## **INQUIRIES AND RESPONSES FOR “PREPARATION OF A PHASE I ENVIRONMENTAL ASSESSMENT AHEAD OF CONSTRUCTION FOR A YOUTH CENTER PROJECT”**

# Proposed Site Option C Location for the Boys and Girls Club Planned Facility

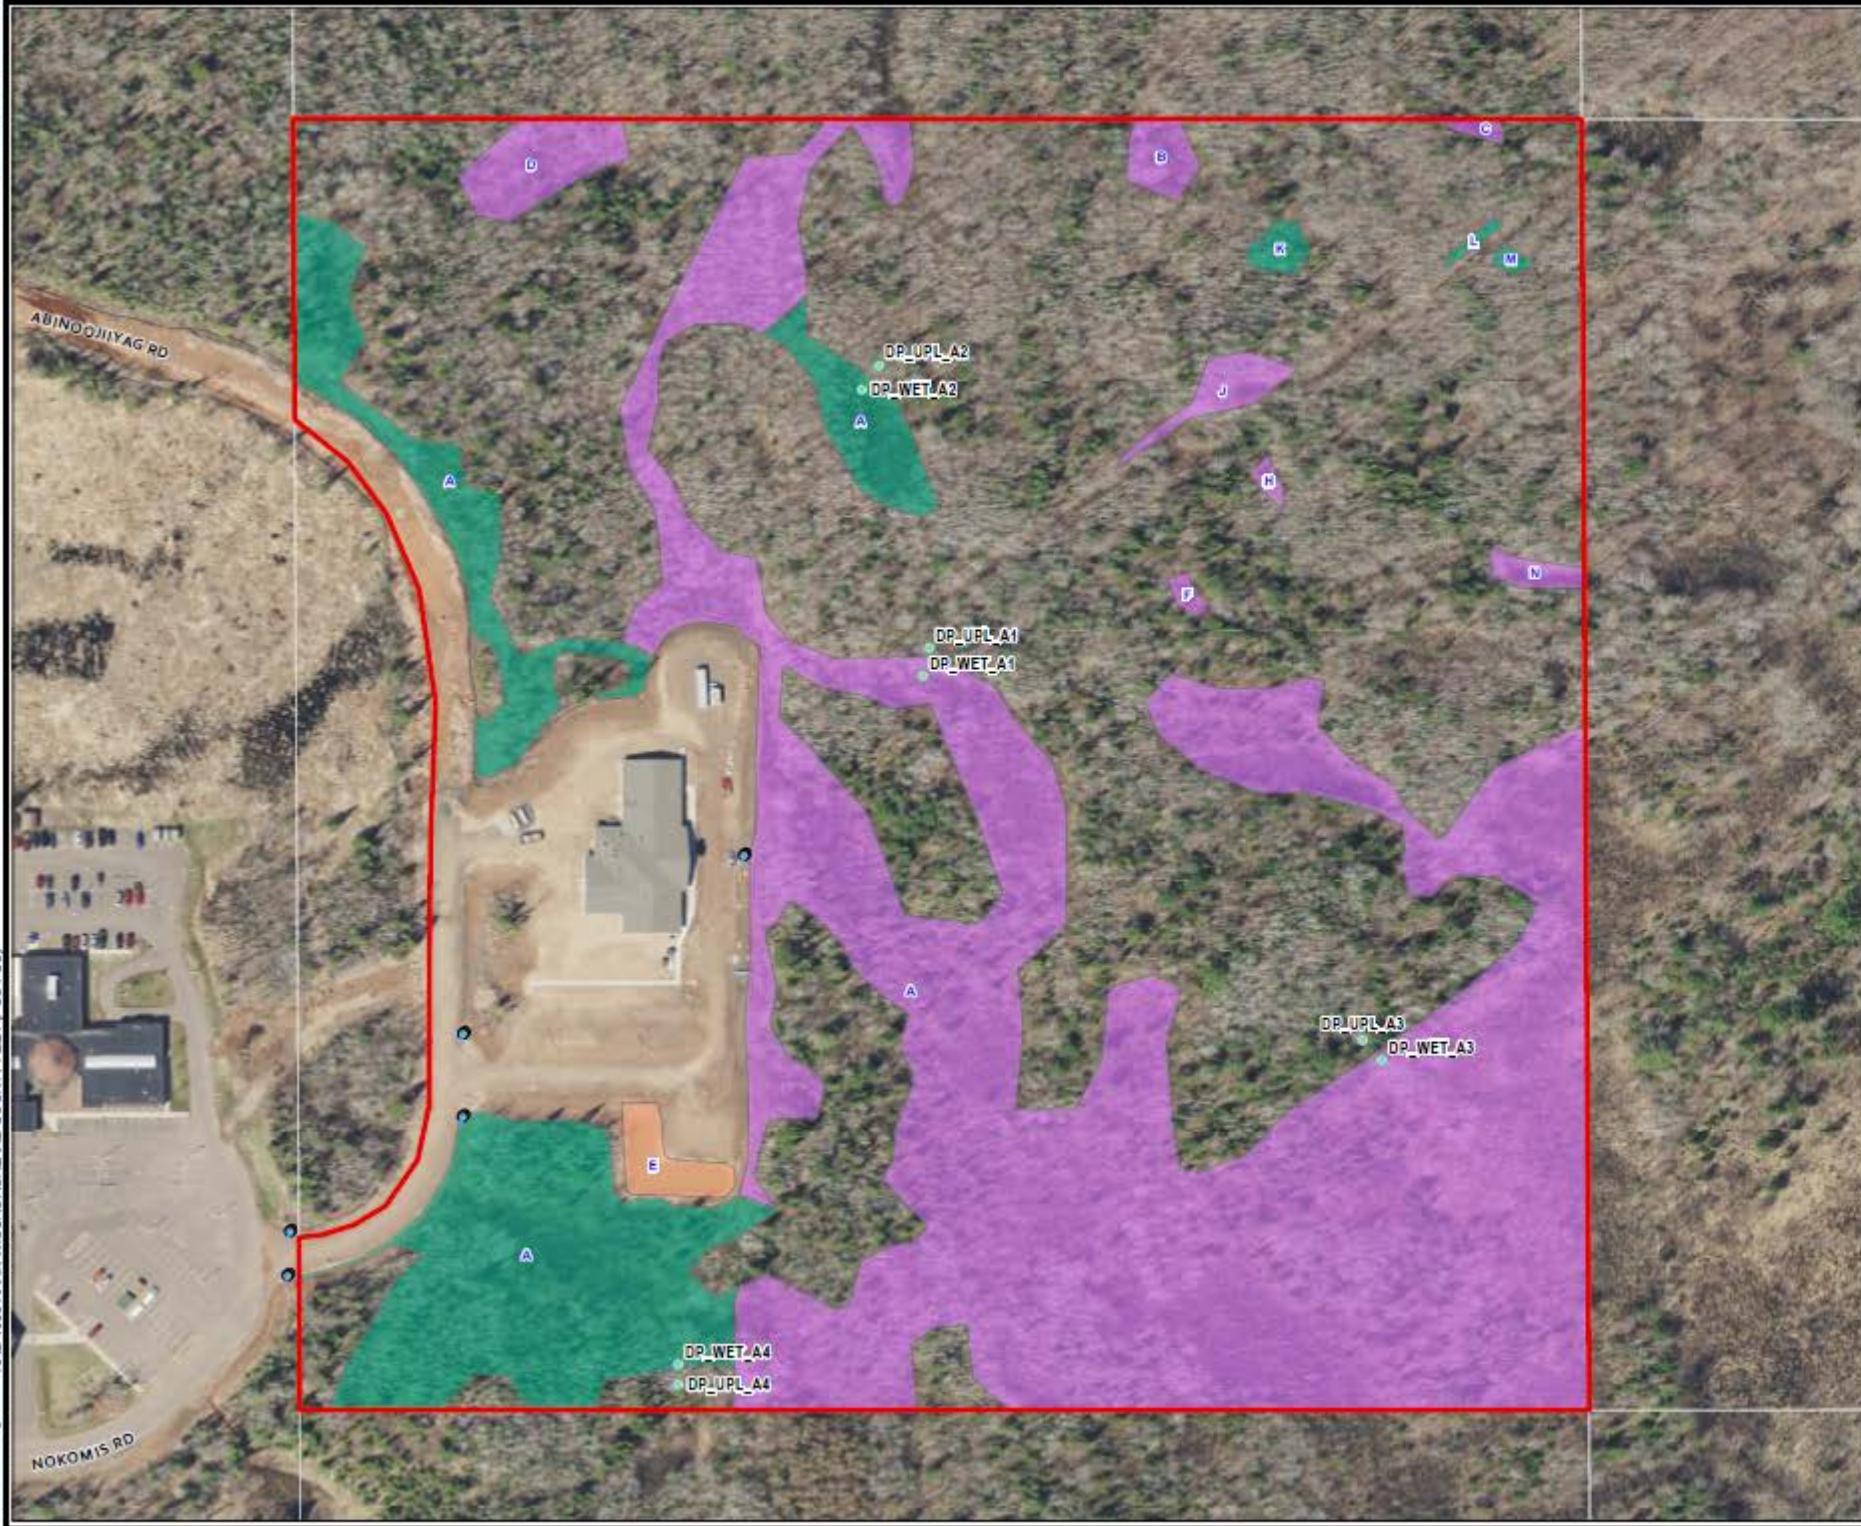
### **Q1. A map that includes grading impacts for the project that would be helpful.**

A1. No map exists to fulfill this need as of now. We have an RFP out for an ASTM survey to include topographical information that may be available at a future date. Until then, please refer to the recent wetland delineation map and estimate building placement diagram that may be useful.

A3. The Band is constructing a new Boys & Girls Club (BGC) building. While design is not yet finalized, one rendition recommended a single-story structure approximately 97' X 120' with parking lot with 15 parking spaces, and an access driveway extending from an as-yet-to-be built 66' wide access road. The access road build out will be done at a later date, but is meant to accommodate future neighborhood growth. The length of access road for this project is likely to be no more than is needed to accommodate the access 90° driveway to facility.
